AGENDA

November 15, 2017 Standards Committee Meeting

RE: Agenda for the November 15, 2017 Standards Committee Meeting

601-R-658d (PAGE 8) MIDWEST GUARDRAIL SYSTEM ASSEMBLY LONG-SPAN (WITH MARKUPS)

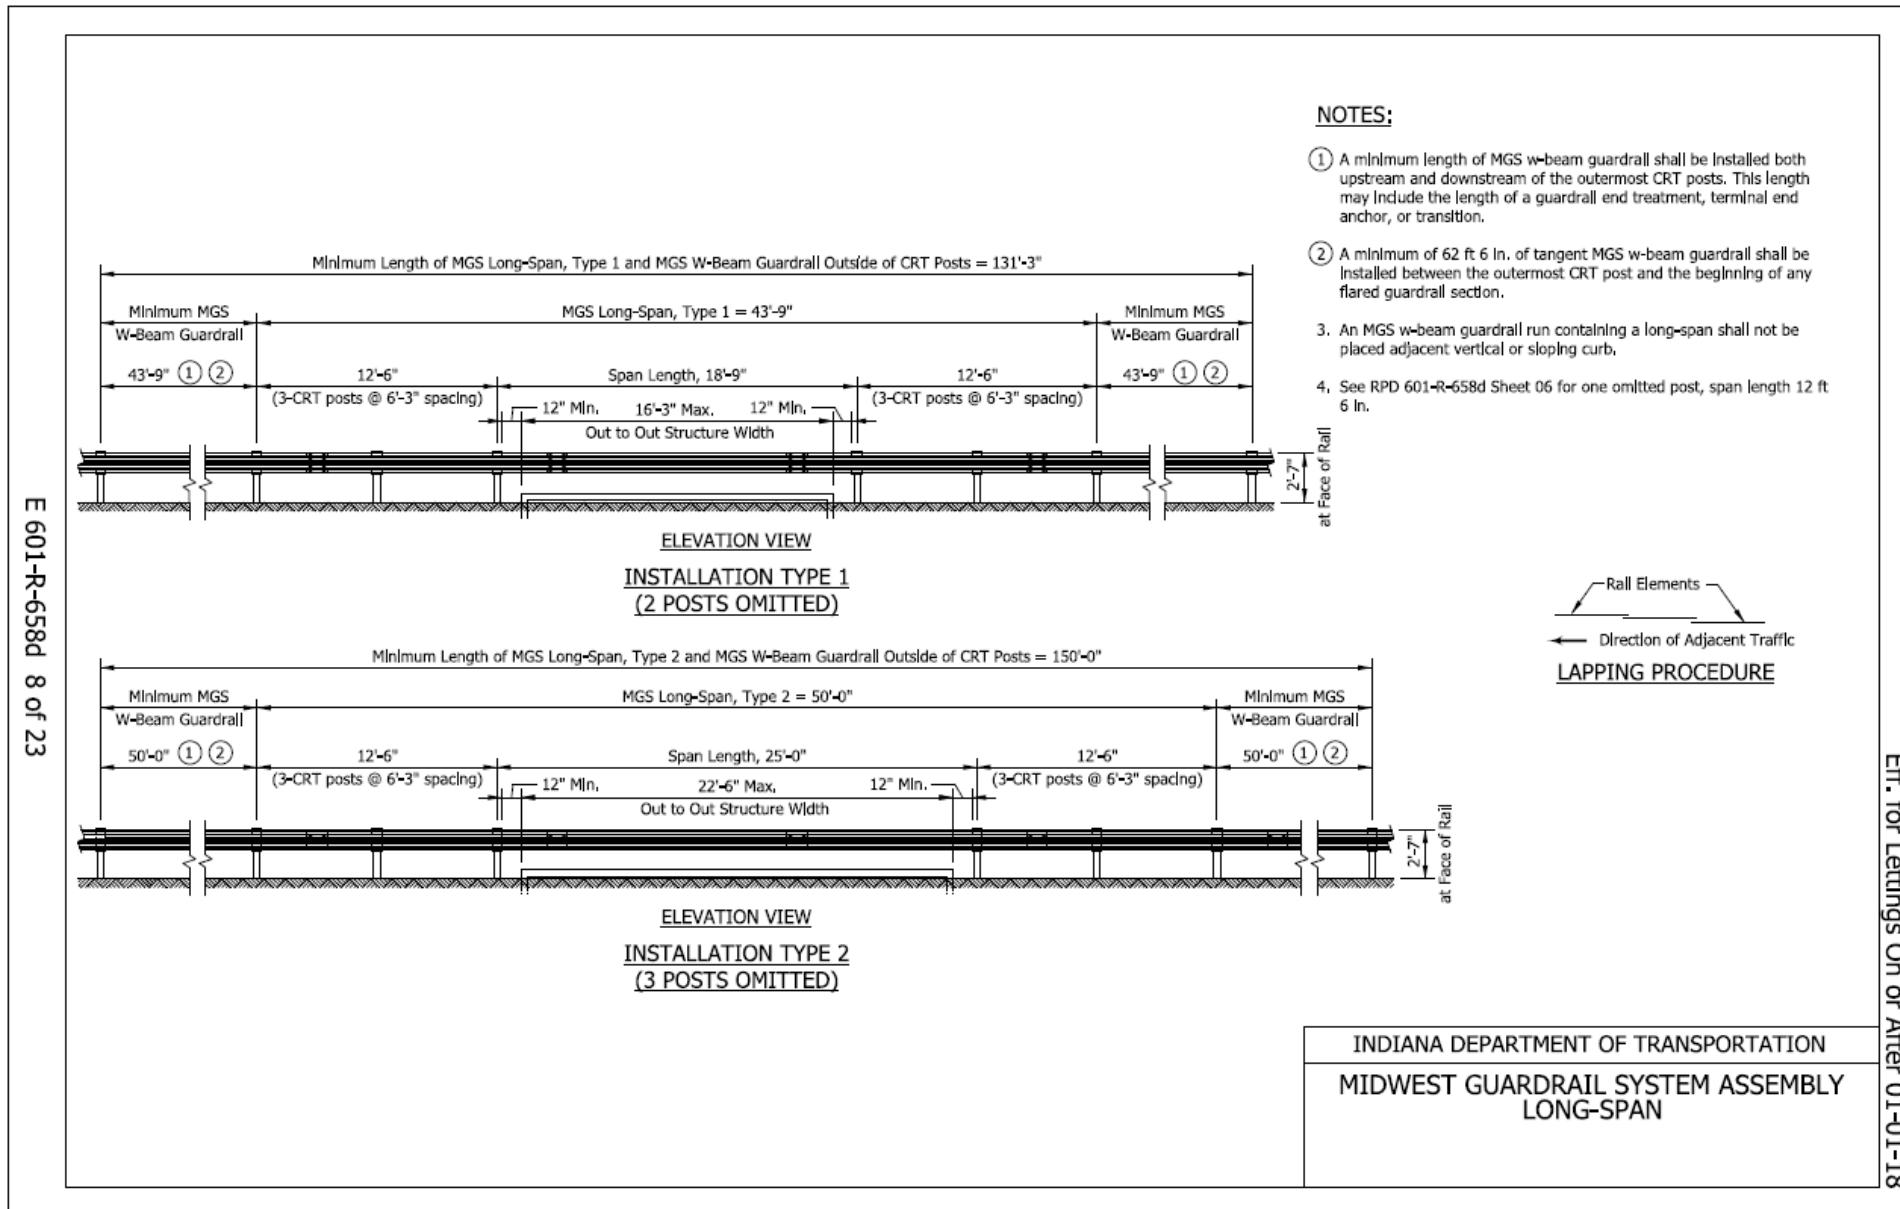
The MGS Long-Span is detailed on sheet 8 of the approved RPD 601-R-658d. The minimum length of MGS w-beam guardrail required upstream and downstream of the outermost CRT post is shown to be included with the MGS Long-Span, Type 1 and Type 2 for both the detail and the pay item. For designer and construction clarity, we believe the pay item for MGS Long-Span should only run between the outermost CRT posts and the minimum length of MGS w-beam guardrail required upstream and downstream of the MGS Long-Span should be paid for separately.

PROPOSED SOLUTION: Revise sheet 8 of the approved RPD 601-R-658d by: Changing the following description, "MGS Standard Post Spacing" to "Minimum MGS w-beam guardrail". The minimum length given on the sheet is not for MGS standard post spacing (6'-3") but for a minimum length of MGS w-beam guardrail which could include a guardrail end treatment, terminal end anchor, transition, or an omitted post in accordance with RDP 601-R658d sheet 6.
